**FAQ Number:** 14-0007

**FAQ Title:** Transient Fire Frequency Likelihood

**Plant:** Exelon: Peach Bottom, Limerick, & TMI

**Purpose of FAQ:**

Figure 1. Example Configuration

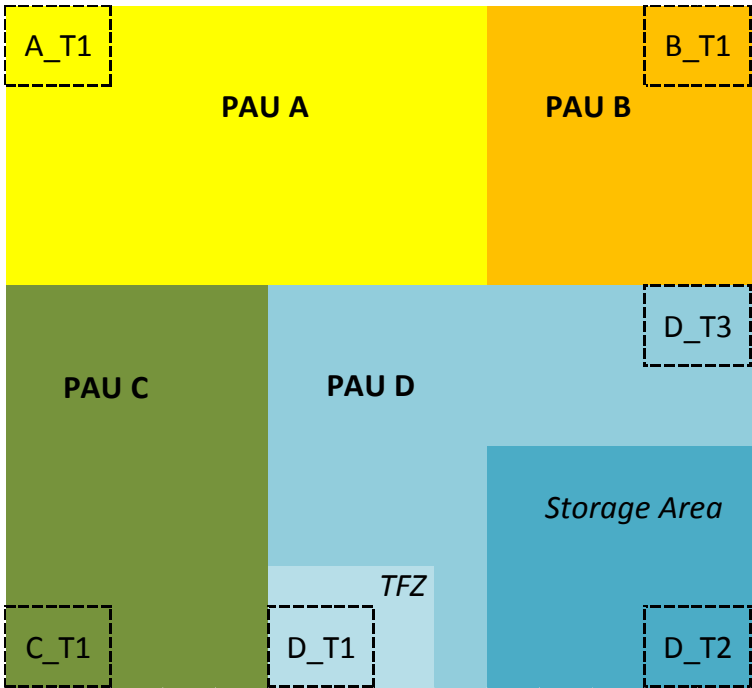
**Comment [A15]:** NEW EXAMPLE. Intended to possibly replace previous example as it better highlights the benefit of the proposed methodology.
